Item Name: Crosstube Turning Detaill

DART AEROSPACE LTD		Work Order:	107458
Description: Crosstube Assembly (206L High Fwd)		Part Number:	D206-667-143
Inspection Dwg: D206-667-143 Rev: C		Page 1 of 2

DRAWING NO. D206-667-143	TITLE CROSSTUBE ASS'Y (206L HIGH FWD)	REV. C	DART AEROSPACE LTD ENGINEERING ORDER		D.E.O. NO. D206-667-143-C-1	SHEET NO. SHEET 1 OF 1	SCALE NTS
DRAWN <i>q</i>	CHECKED <i>ASS</i>	MFG. APPR. <i>MD</i>	APPROVED <i>MD</i>		DE APPR. <i>MD</i>		
DATE 11.07.15	DATE 11.07.20	DATE 11.07.21	DATE 11/07/21		DATE 11.07.21

DRAWING NO. D206-667-143	TITLE CROSSTUBE ASS'Y (206L HIGH FWD)	REV. C	DART AEROSPACE LTD ENGINEERING ORDER		D.E.O. NO. D206-667-143-C-2	SHEET NO. SHEET 1 OF 1	SCALE NTS
DRAWN AJ5	CHECKED	MFG. APPR. <i>E</i>	APPROVED <i>AP</i>		DE APPR. <i>TH</i>		
DATE 12.08.02	DATE 12.08.02	DATE 12.08.02	DATE 12.08.02		DATE 12-08-02

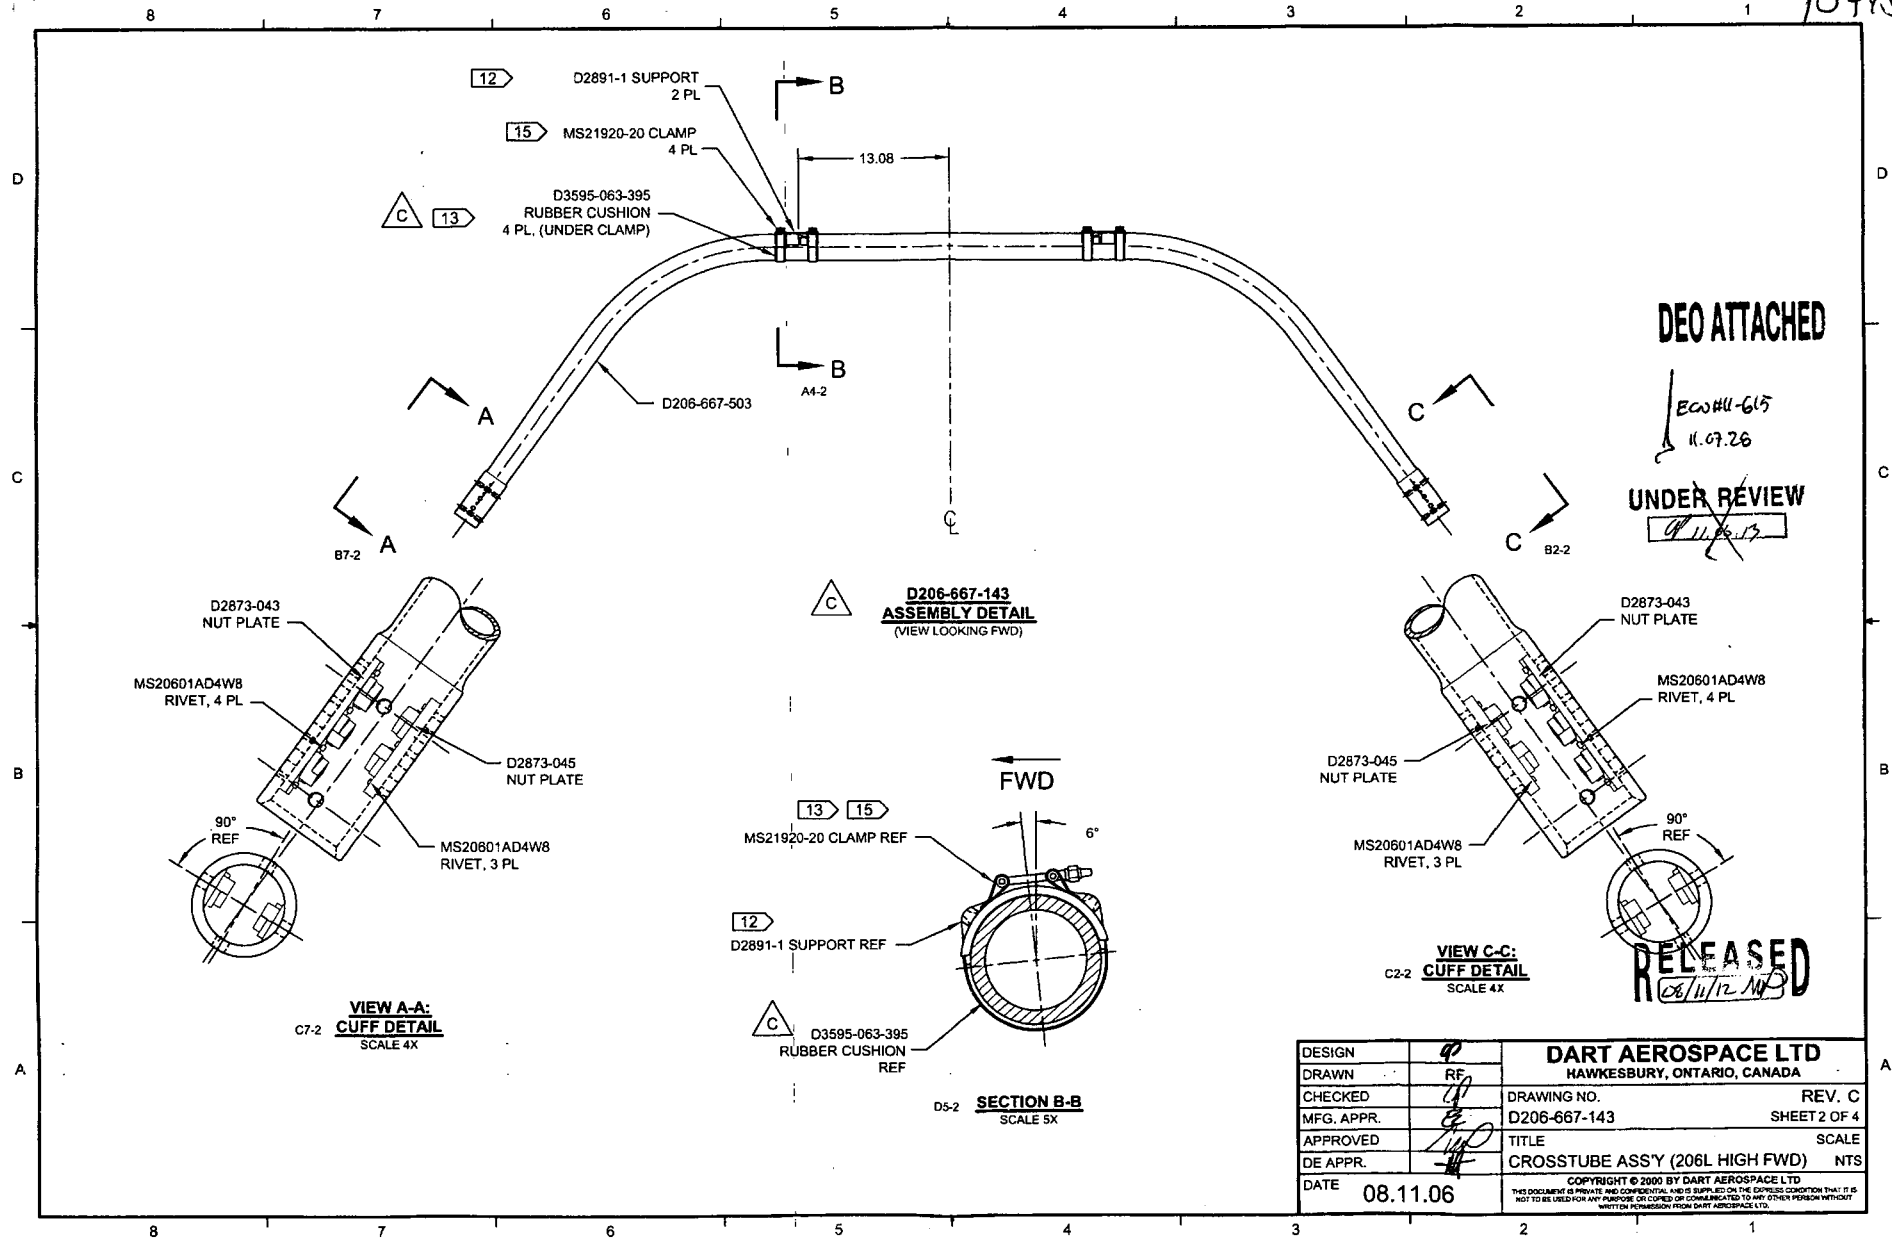
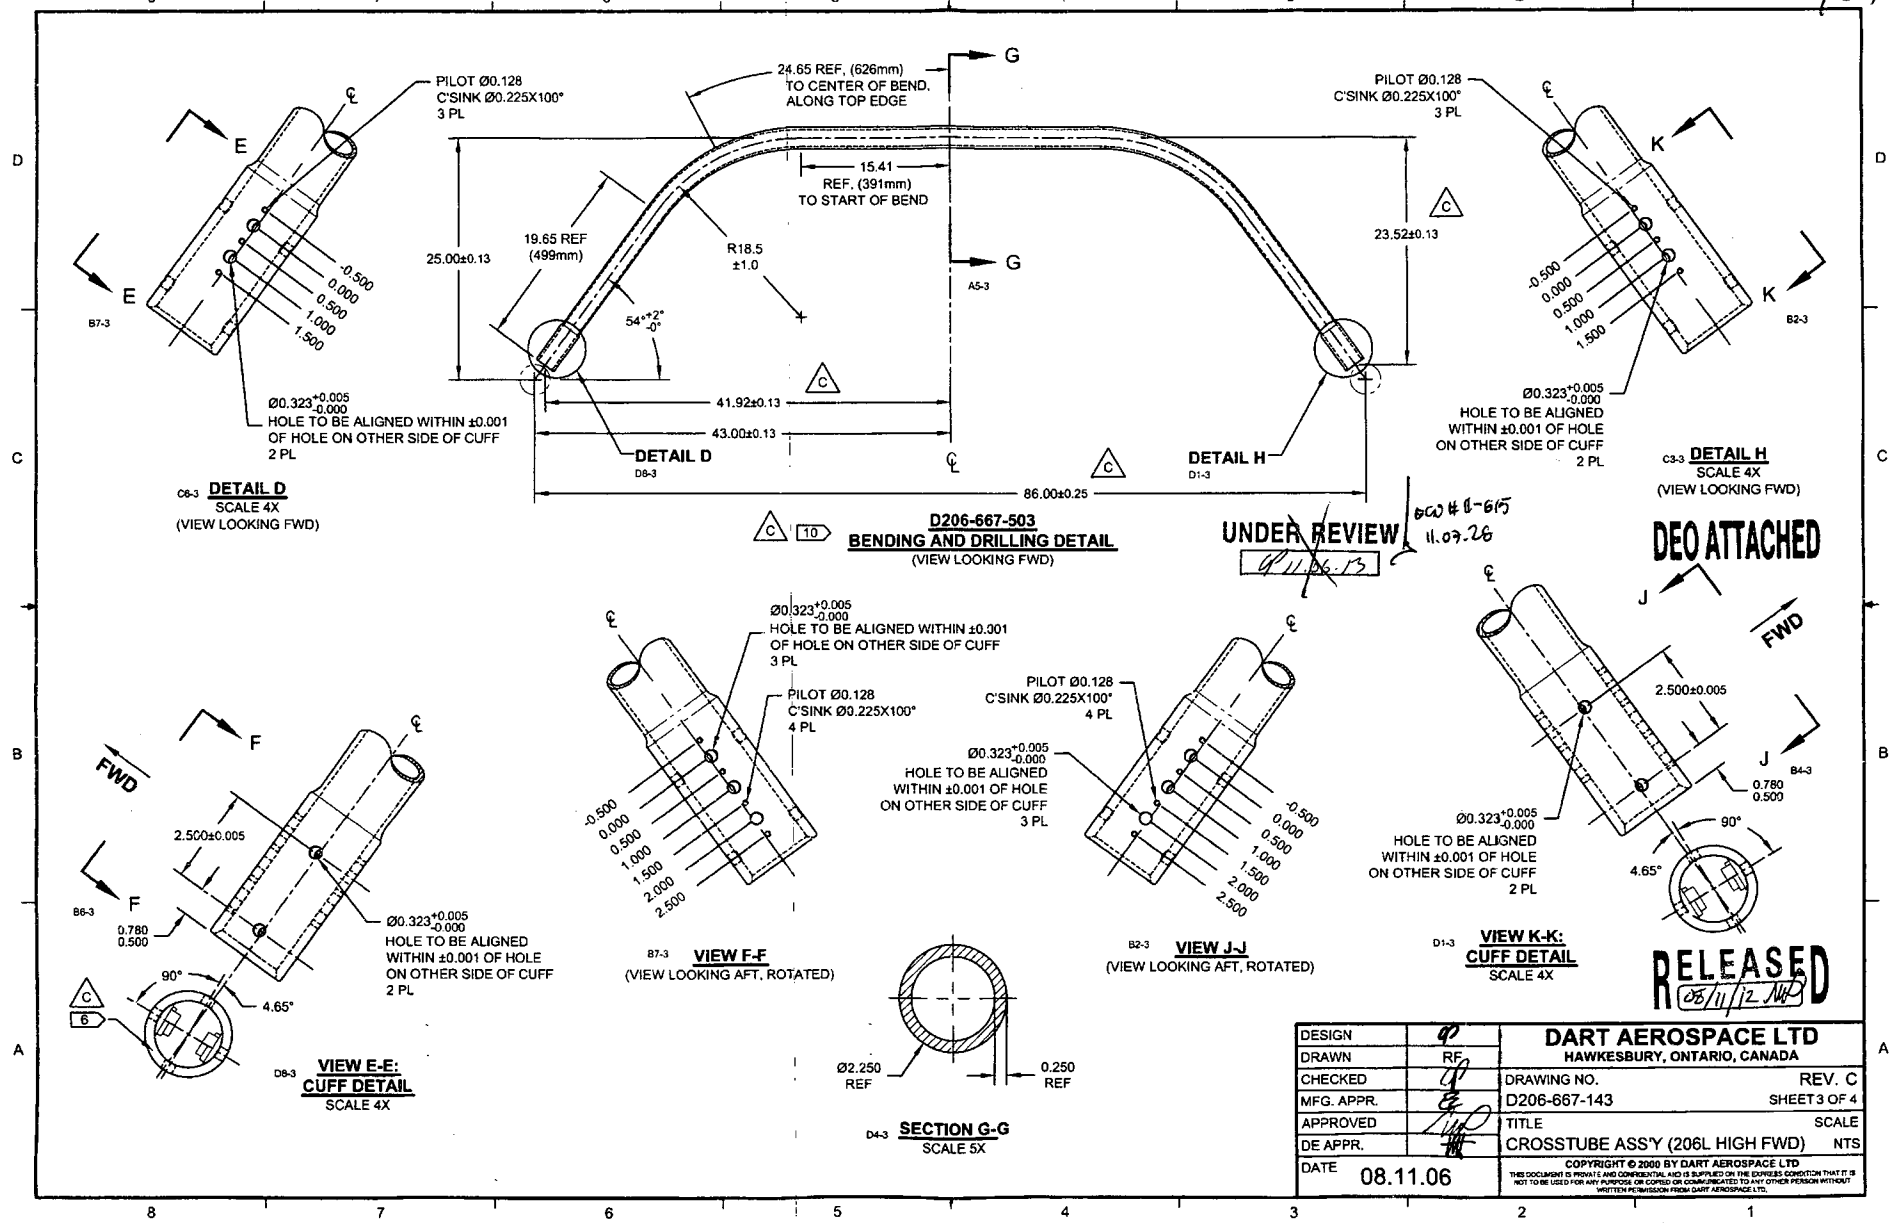
REPLACE MAGNOBOND WITH PROSEAL.

NOTE 12 & 15, SHEET 1 IS AMENDED AS FOLLOWS:

- 12) TO INSTALL D2891-1 SUPPORT: ABRASE MATING SURFACE OF SUPPORT AND CROSSTUBE WITH 180-GRIT SANDPAPER AND REMOVE RESIDUE WITH MEK (OR EQUIVALENT). APPLY A 0.04" TO 0.07" THICK LAYER OF PROSEAL 890 CLASS B-2 (OR AMS-S-8802 CLASS B-2) SEALANT TO MATING SURFACE OF SUPPORT.
- 15) TORQUE CLAMPS 80 TO 100 IN-LB. ENSURE AT LEAST 1.5 THREADS SHOWING IN SAFETY AND THAT NUT HAS NOT BOTTOMED-OUT AFTER TORQUING. **PRIOR TO PACKAGING, RE-CHECK TORQUE ON CLAMPS AFTER PROSEAL 890 SEALANT HAS CURED FOR 72 HOURS.**

DETAIL P
BONDING STRAP INSTALLATION 2 PL

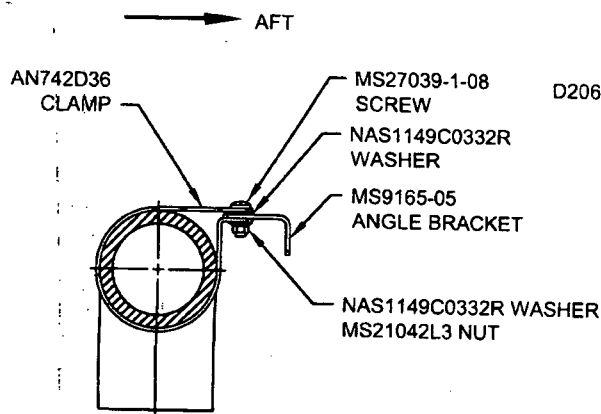
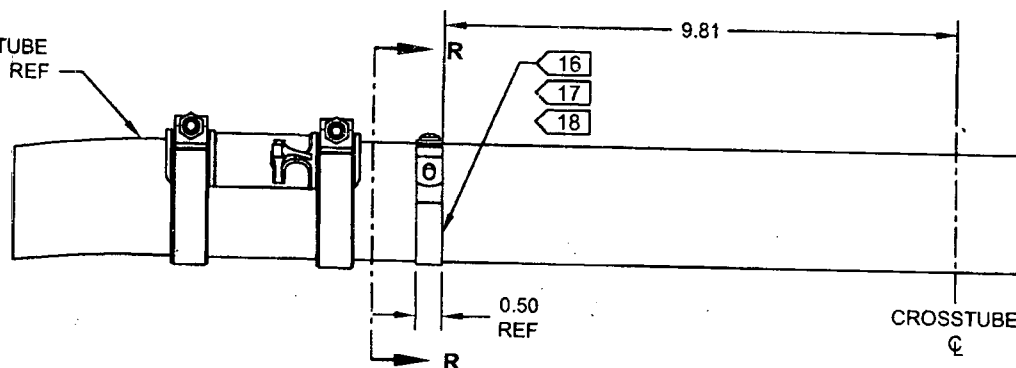
ADD ELECTRICAL GROUNDING STRAP

ITEM	QTY -143	PART NUMBER	DESCRIPTION
1	X	D206-667-143	CROSSTUBE ASSEMBLY (206L HIGH FWD)
10	2	AN742D36	CLAMP
11	2	MS9165-05	ANGLE BRACKET
12	2	MS21042L3	NUT (OR MS21042-3)
13	2	MS27039-1-08	SCREW
14	4	NAS1149C0332R	WASHER (OR AN960C10L)

- 16) MASK AREA UNDER CLAMP PRIOR TO PAINTING
- 17) SEAL EDGES WHERE AN742D36 CLAMP MEETS WITH THE CROSSTUBE USING SIKAFLEX-241/-291 OR MIL-S-8802 CLASS B2 OR PROSEAL 890 SEALANT
- 18) PERFORM RESISTANCE CHECK TO ENSURE MAX RESISTANCE IS 10 MILLIOHMS
